Subject: Recirculated Draft Environmental Impact Report for Cottonwood Sand Mining

Project (PDS2018-MUP-18-023), (PDS2018-RP-18-001); Log No. PDS2018-ER-18-19-

007; SCH# 2019100513

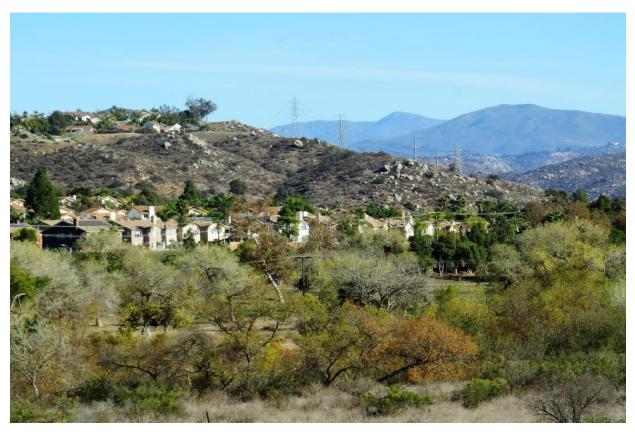
The RDEIR documents indicate that a second conveyor will be used to transport backfill material and that the mining operation noise is assessed as potentially significant. Mitigation measures indicated that one area near to the sand mine location will have its proposed noise barrier increased from 8-feet to 12-feet. This potential barrier eyesore in one area will not mitigate the high level of cumulative noise experienced by all community residences around the sand mine location, especially residences at higher elevations.

The proposed project adds 66% more truck trips and 100% more conveyors. The plan to raise a wall to 12 feet instead of 8 feet does NOT do anything to mitigate the noise impacts.

The proposed sand mining project is in a valley with residences up the sides of the valley in an elevated position. The direction of the sand mining operation noise will travel to these communities unencumbered by the existing project site topography, vegetation or the sound barriers proposed. The RDEIR must be revised to include a more thorough analysis of the potential noise impact as it relates to the equipment proposed to be used as well as the more complex analysis of noise impacts for all surrounding residences/communities both level to the project property site and at a variety of elevated positions. See below image showing an example of residences at higher elevations.
